<b>T.I. no.:</b> 2020 - 19 <b>Updated:</b> -	<b>Topic:</b> SC Club – Product optimisation hose routing
---	---

## OPTIMISATION HOSE ROUTING

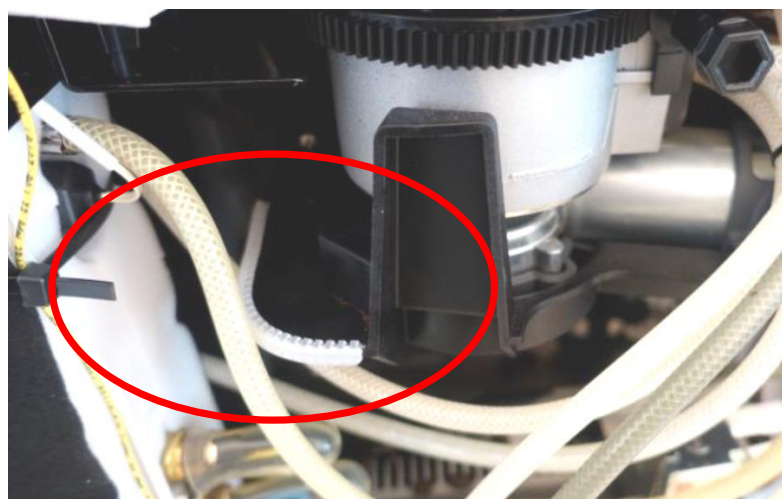
Due to individual reports from the field, an additional edge protection was fitted to the plastic support of the coffee grinder in order to prevent possible damage to nearby hoses.

The edge protection can be retrofitted without any problems and can be ordered by meter with the following item number:

- 00.0048.0090 edge protection PE natural
- per machine 10 cm edge protection is required

We recommend retrofitting the edge protection during the next service visit on machines in the field. If a hose is already damaged, replace the hose in order to avoid possible subsequent problems.
